Access Compliance Report Public Rights-of-Way (Curb Ramps)

Main Street: DANA_POINT_HARBOR_DR Cross Street: PUERTO_PL Location: SE

ADA ID: RPRK220208144328 Ramp Type: Type 4 - Parallel Initial Pass/Fail: Fail Overall Compliance: No Severity Score: 16

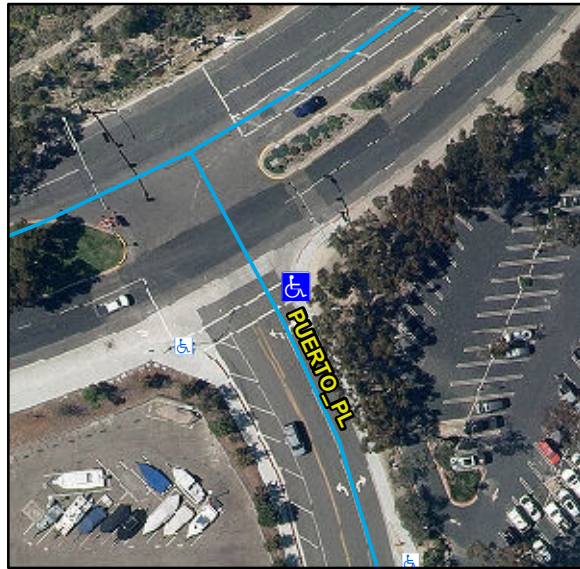
R304.3.2, R304.5.3, STD 1115

Remove & Replace Curb Ramp With Two New Directional Ramps or Equivalent.
